Flight Procedures Cover Page	Task Action: Abbreviated Amendment	Task Type: SID	Estimated Chart Date: 10/29/2026	APWS Task ID: E87D6C6215A74B1F81B81D5F4C30C722	APWS Project ID: E4CCE99CFBB540E98912F9DC298085A3
Procedure: ZAAPA SEVEN (RNAV) CLEVELAND, OH KBKL		Enroute: YES	Specialist: Keefer, John		Agreement Number:
Airport ID: KCLE			Airport City: CLEVELAND		State: OH
Facility ID:	Facility Type:	Flight Inspection Remark Type:			
Procedure Comments: Procedure amended to remove BKL. BKL will receive a new SID. Active airport data used. PROCESSED IAW TECHNICAL SUPPORT GROUP (AJF-17) MEMO DATED 07/07/2021 GUIDANCE FOR PROCEDURAL CHANGES REQUIRING FLIGHT INSPECTION/VALIDATION. Contact April Sarmento 405-954-0337. QUALITY 23 CHECKED QUALITY 41 CHECKED

BURKE LAKEFRONT (BKL)
CLEVELAND, OHIO

ZAAPA SIX DEPARTURE (RNAV)

ZAAPA SIX DEPARTURE (RNAV)
(ZAAPA6.ZAAPA) 27NOV25

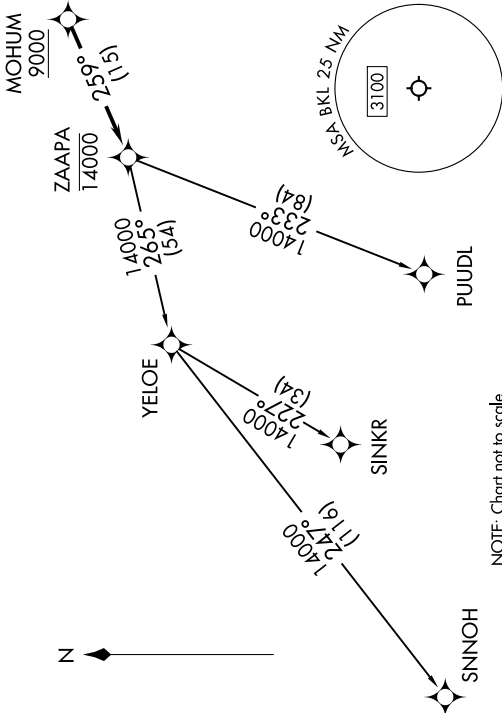
TAKEOFF RUNWAY 6L/R: Climb on heading 065° to 1100, then on heading 349° or as assigned by ATC, maintain 2000 (do not climb above 2000) for RADAR vectors to cross MOHUM at or above 9000, thence....
TAKEOFF RUNWAY 24L/R: Climb on heading 245° to 1100, then right turn heading 349° or as assigned by ATC, maintain 2000 (do not climb above 2000) for RADAR vectors to cross MOHUM at or above 9000, thence....
....on track 259° to cross ZAAPA at or below 14000, then on (transition). Maintain ATC assigned altitude, expect filed altitude ten minutes after departure.
